Western Digital Corporation  
 5863 Rue Ferrari  
 San Jose, CA, 95138

To: T10 SAS Protocol Working Group  
 Contact: Mark Evans  
 Phone: 408.363.5257  
 Email: mark.evans@wdc.com  
 Date: [13 January 2009](#)

Subject: [SPL](#), Low power transceiver options, phy states

Figure a — PS (phy layer) state machine - SAS phy power management states

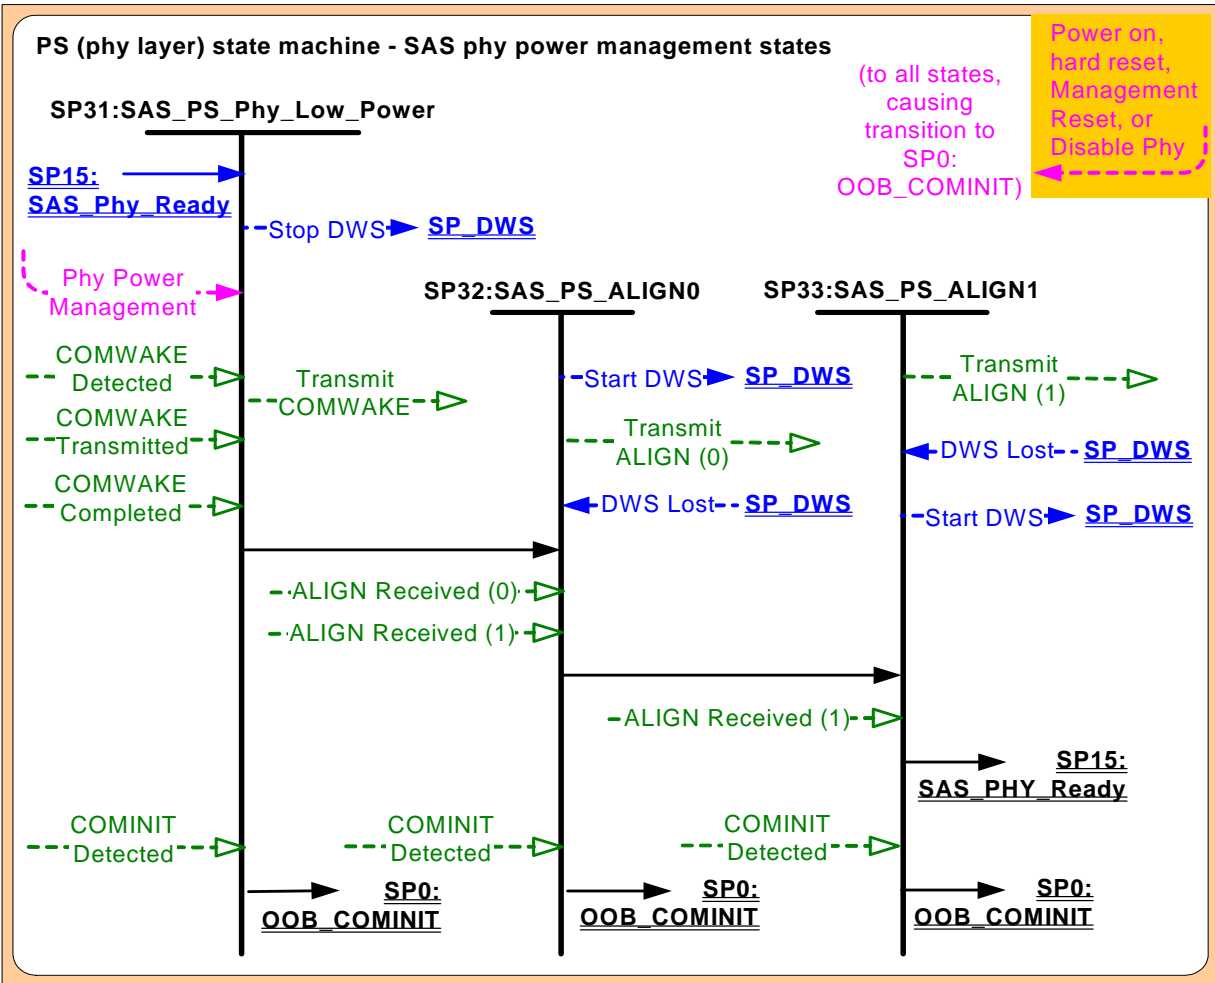
[Editor's note: this is a new clause with a new figure. The numbers of the clauses regarding SATA that follow increment by one (e.g., 6.8.5 becomes 6.8.6), and the numbers of all subsequent figures increment by one.]

Figure a shows the SAS phy power management states. These states are entered when a phy is requested to enter a phy low power condition (i.e., the partial phy power condition or the slumber phy power condition) and process the actions that return a phy from a phy low power condition to the active phy power management condition (i.e., participating in an operational logical link).
